Ref. No. 201502031 Petition No. 513

PETITION NO. 513 SUNKISS MARKET 13535 PURITAN AVE. DETROIT, MICHIGAN 48227 C/O DANNY THWENI PHONE NO. 313 482-7371

- REQUEST ENCROACHMENT (With HVAC Units)

B A						REQUEST ENCROACHMENT	CITY EN	Y OF DETROIT GINEERING DEPARTMENT
-	DESCRIPTION DRWN CHKD APPD DA' REVISIONS				DATE	INTO EAST/WEST ALLEY, 18 FT. WD.	SURVEY BUREAU	
DR.	AWN BY WLW	CHEC	KED			AT 13535 PURITAN AVE.	JOB NO.	01-01
DA	те 02-11-15	APPROVED				(With HVAC Units)	DRWG. NO.	X 513

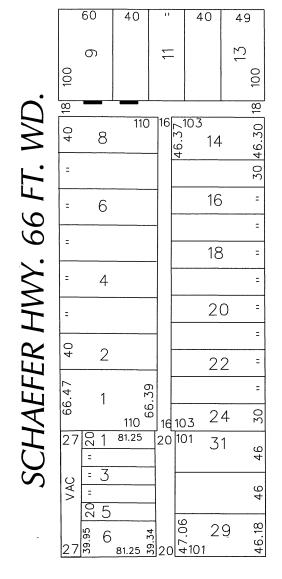
- () Not Involved.
- () Involved; but asking you to hold action on this petition until further notice.
- () Involved; the nature of our services, and the estimated costs of removing and/or rerouting such services are:
- (X) Involved; have no objection to the request for encroachment into east/west alley, 18 ft. wide at 13535 Puritan Ave. (with HVAC Units) as shown on drawing no. x513 dated 02/11/2015 provided that a vertical clear height/ under clearance of minimum 12 ft shall be maintained under the aerial encroachments.
